Boston Alternative Energy Facility

Worst Case Assessment for Land Raising (Clean)

Document Reference: 9.77 (1)

Subject: Boston Alternative Energy Facility: Deadline 9 - Worst Case Assessment for Land Raising

TITLE **BOSTON ALTERNATIVE ENERGY FACILITY DEVELOPMENT CONSENT ORDER Regulation 5(2)(o) - Technical Note - Deadline 7 Worst Case Assessment for Land Raising Figure 1**

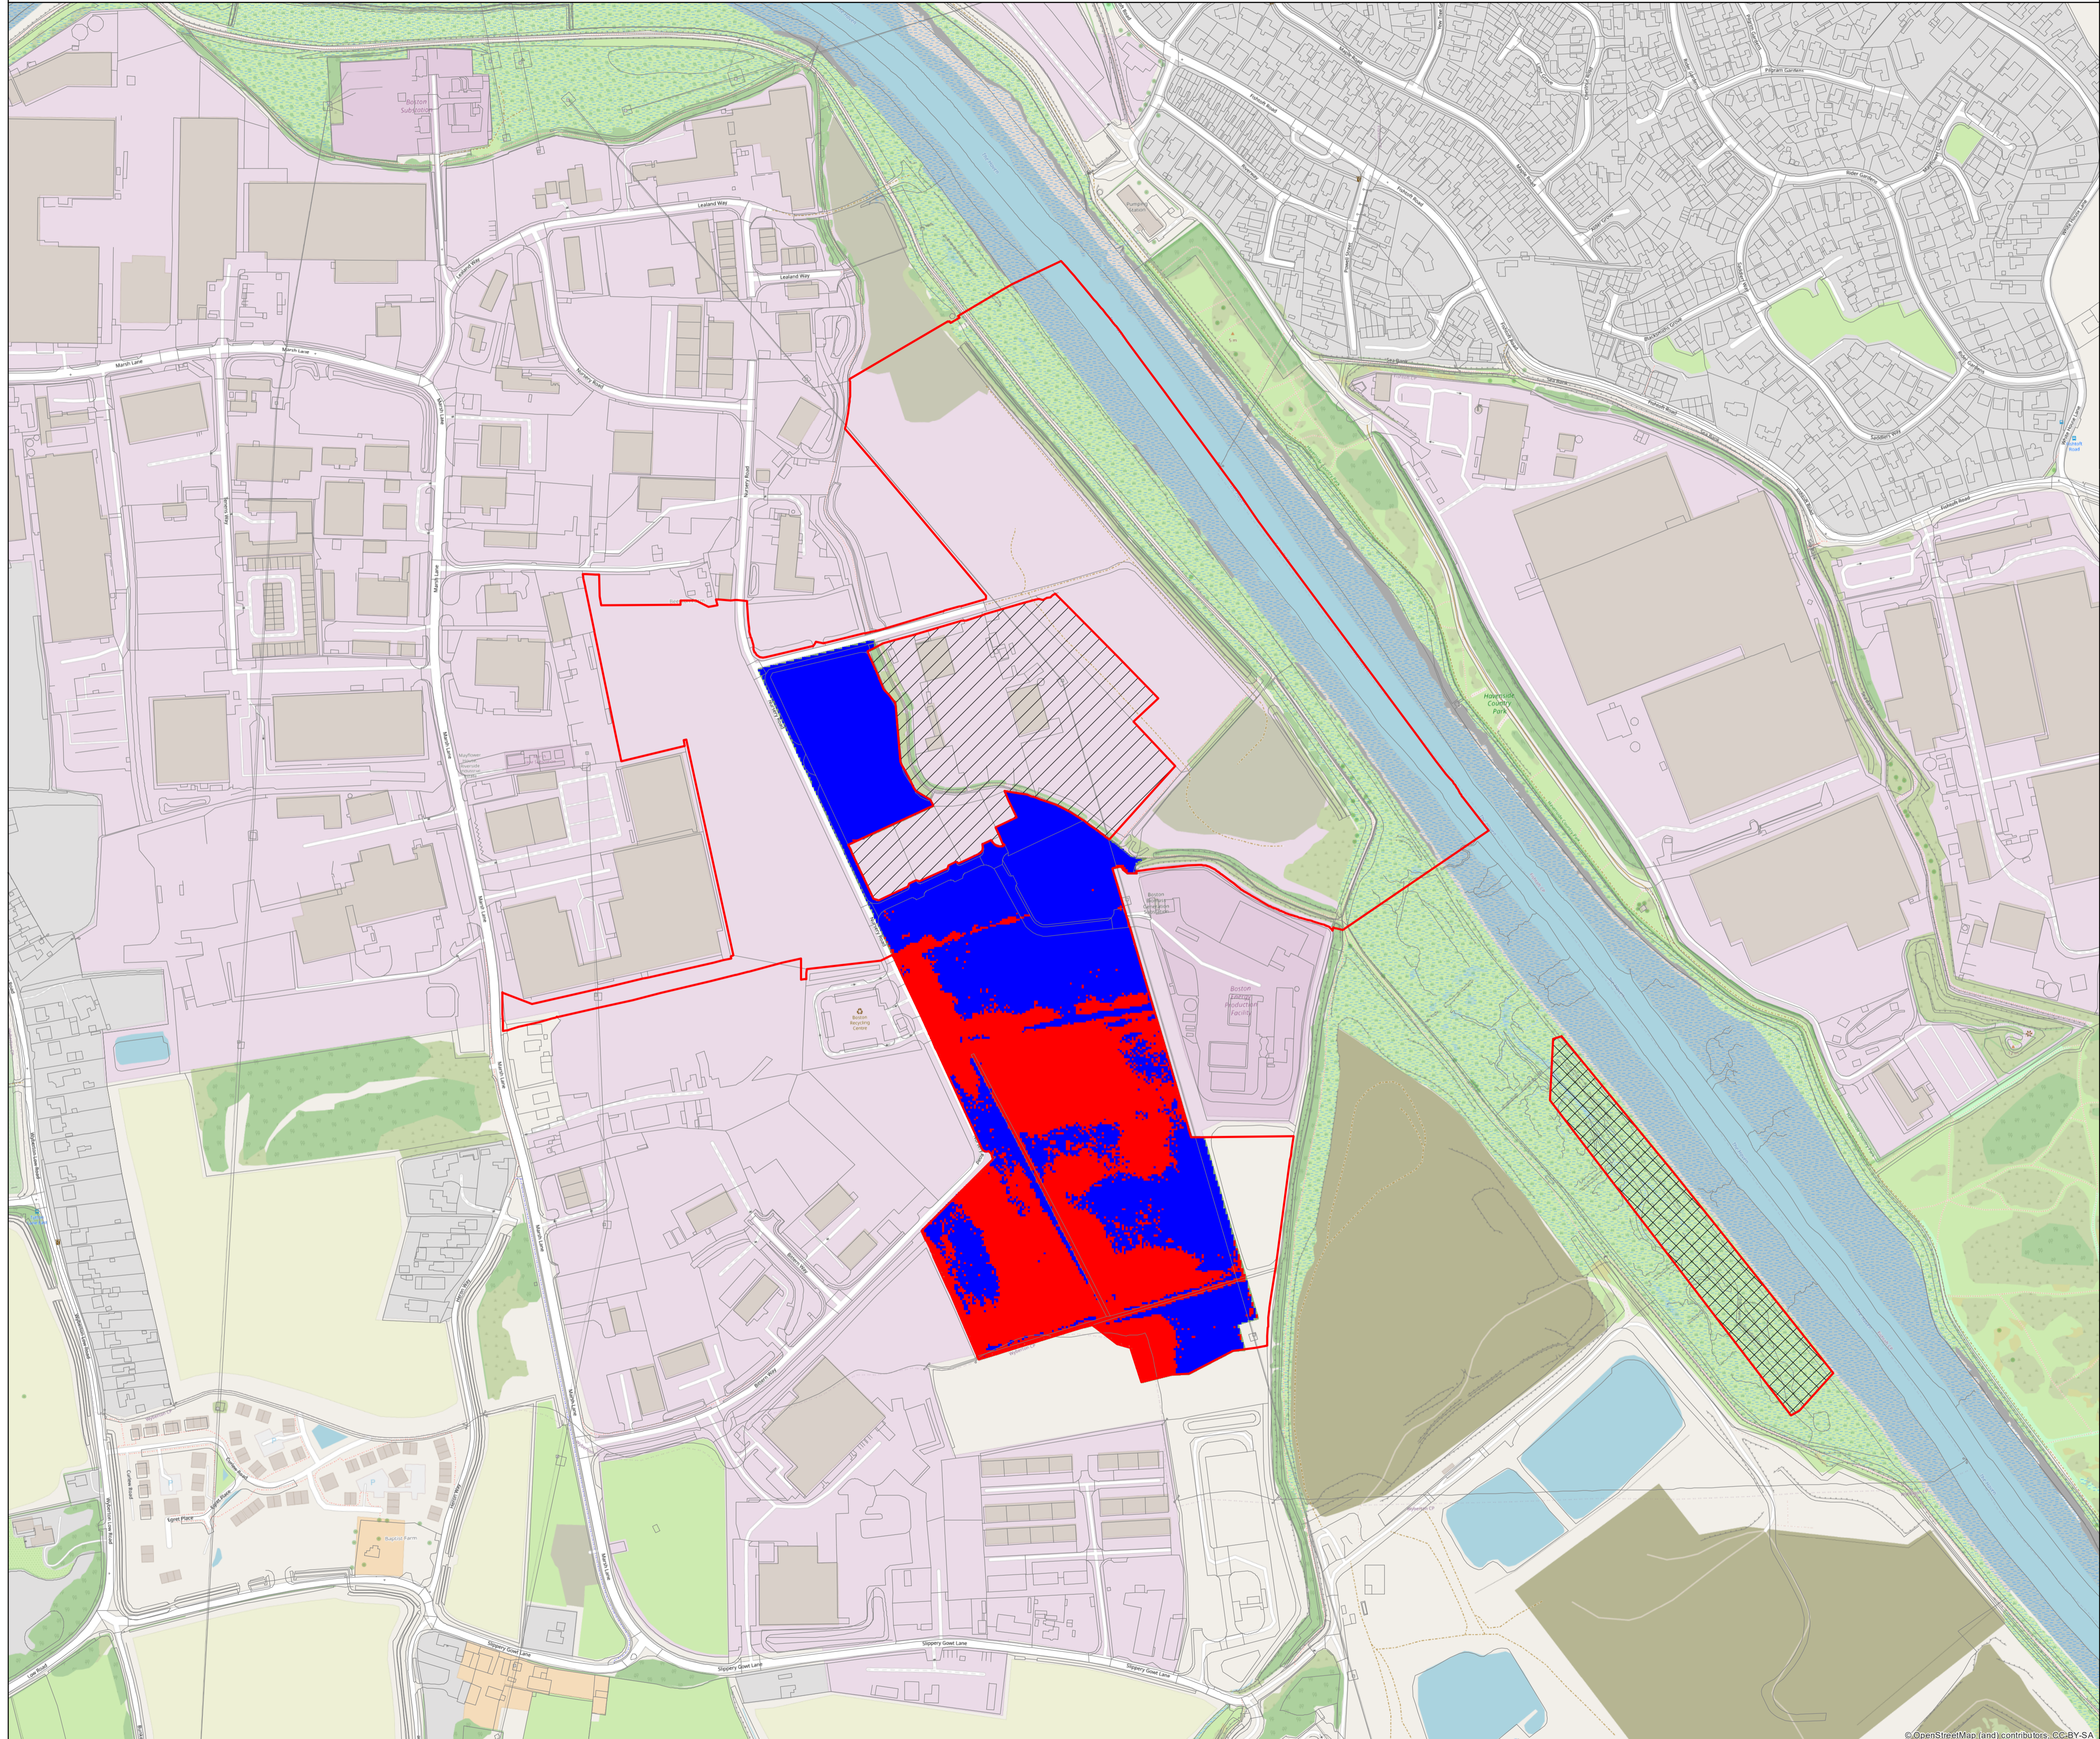
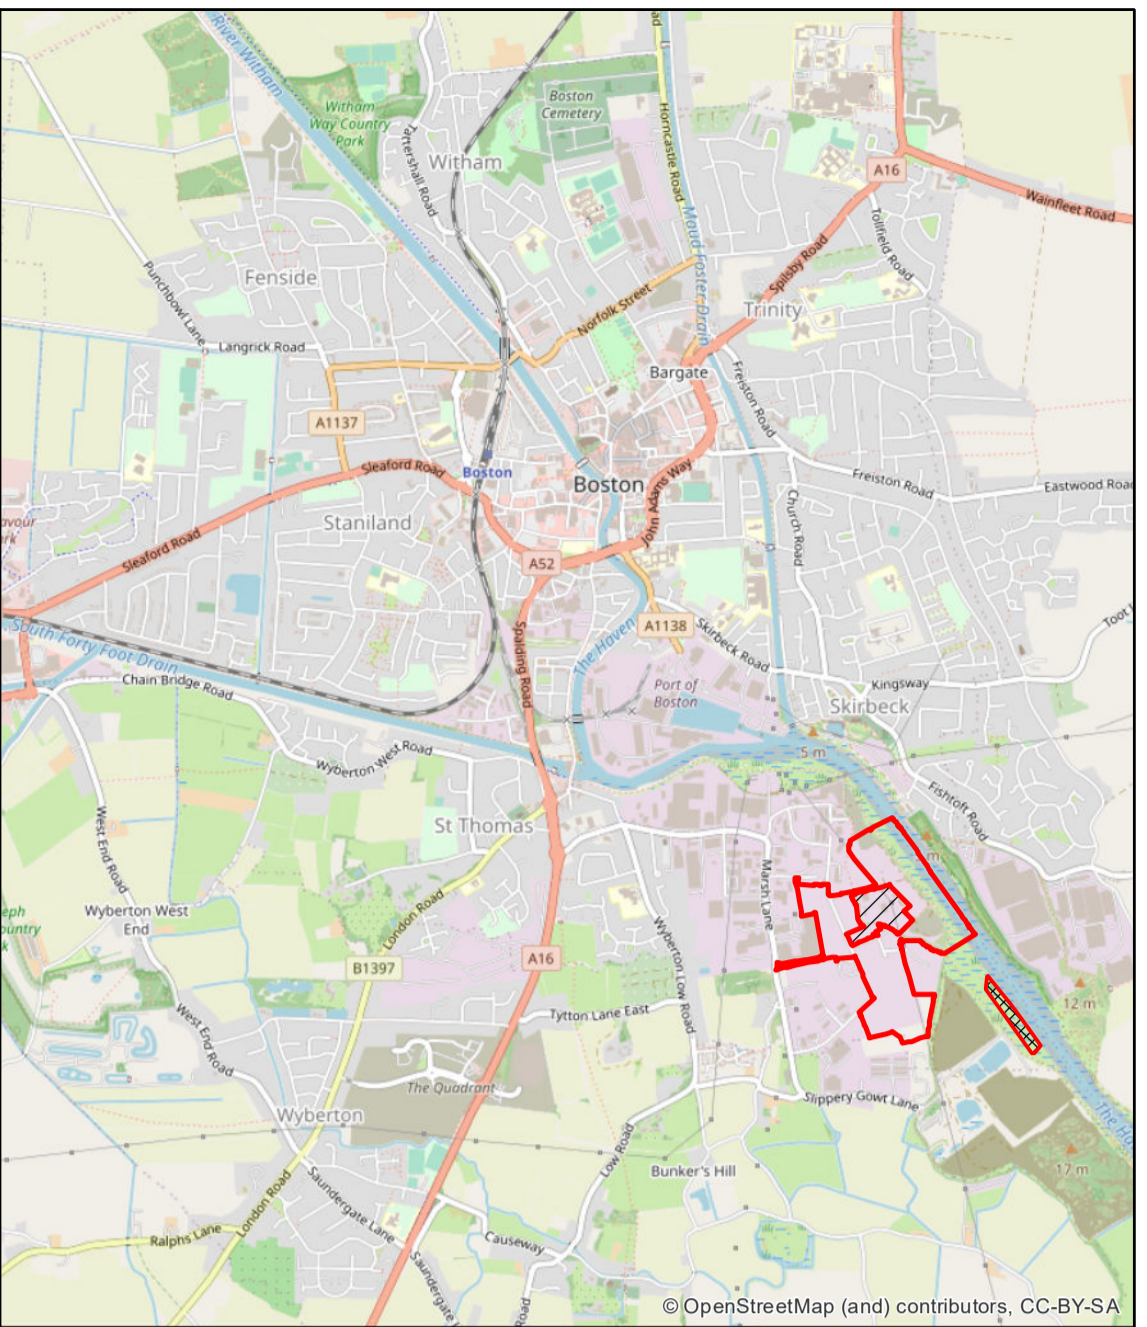
2.4. We have reviewed document ref REP7-009 (Worst Case Assessment for Land Raising). We consider the document is a reasonable assessment of the possible impacts on flood flows as a result of land raising and has addressed some of our concerns. However, the assessment does not include an assessment of works taking place in the area between the proposed wharf and Roman Bank. The assessment must be updated to see what impact (if any) may arise as a result of works in this area.”

- 4.1.3 Furthermore, it is noted that, in their Deadline 8 submission (REP8-019), the Environment Agency requested the same assessment be undertaken for the land between the proposed wharf and the Roman Bank. However, the Applicant notes that this part of the site has also been omitted from the assessment on the basis that the land in this location will not be subject to the same cut and fill exercise as the Principal Application Site.

- 4.1.2 As can be seen in **Figure 1**, the land subject to levelling is focused on the Principal Application Site. The land proposed for the construction car parks and laydown areas, to the west and north west of Nursery Road will not be subject to ground levelling. Therefore, these areas have been excluded from the assessment.

- 4.1.4 Whilst it is acknowledged that the undeveloped site, comprising mainly agricultural land, may have some minor localised variations in topography (noting it is currently a relatively flat site) there is no proposal for a comprehensive cut and fill exercise to adjust the level of the land either up or down between the proposed wharf and the Roman Bank.

- 4.1.5 In addition, the proposed wharf is to be located to the riverward side and in line with the footprint of the existing defence extending inland only as far as the rear of the existing embankment. After this point there will be a drop in the level from the proposed wharf to the development behind so that it matches the existing ground levels to the rear of the existing defence.

- 4.1.6 It is on the basis of the above that the land between the proposed wharf and Roman Bank has been omitted from the assessment as no change in ground levels means there will be no reduction in flood storage in this location post-development compared with the existing scenario.
